**9-1– 12**  
**901.1, 905.1**

**Proposed Change as Submitted**

**9-5– 12**  
**903.5, Figure 903**

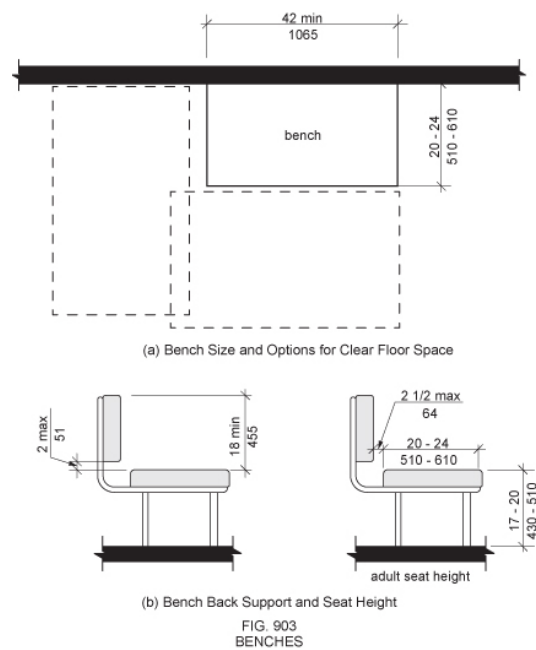
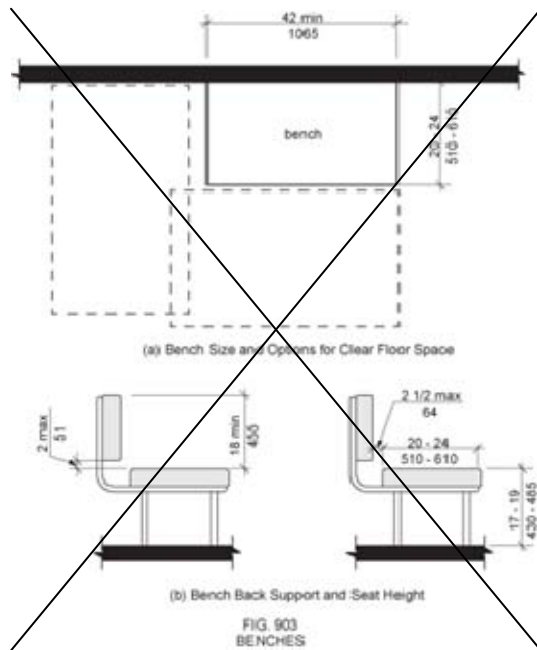
**903.5 Height.** The top of the bench seat shall be 17 inches (430 mm) minimum and ~~19~~ 20 inches (485 510 mm) maximum above the floor, measured to the top of the seat.

However, a fixed seat any higher than 20 inches (510 mm) would likely disadvantage people of short stature, particularly if it was the *only* seat. Encouraging innovation would help to accommodate a greater number of wheeled mobility users without disadvantaging people of short stature. Adjustability is the best option to accommodate the widest population but in the meantime, the upper limit should be raised to 20 inches (Steinfeld, et al., 2010, pgs. 85-86).

NOTE: This change necessitates a change to Fig. 903 to ensure consistency. Thus, the proposed revised figure has been attached, along with the existing figure for comparison purposes.

**Committee Reason:** Consistent with other decisions regarding the height to which people would transfer, the Committee is uncomfortable with raising the top of the range to 20 inches.
